**Number:** TSB-FC-2015-027 Advolution 2710/  
UHR 70-1700

**Symptom:** Pad Drive Deck not re-lowering to the  
floor

**Date:** July 22nd, 2015

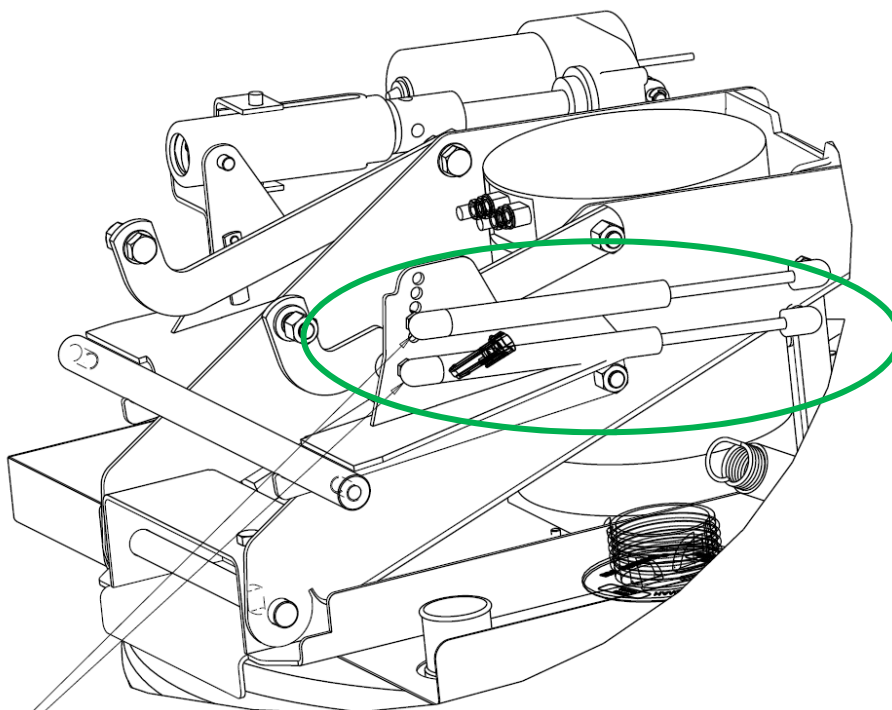
**FIELD CORRECTIVE ACTIONS:** All machines built prior to Serial Number 4000092745

The base end of the upper gas cylinder will need to be moved from the third hole from the top to the fourth hole from the top .

←PLACE GAS CYLINDERS IN FOURTH HOLE FROM THE TOP AND IN THE BOTTOM HOLE.

4th hole  
from the top
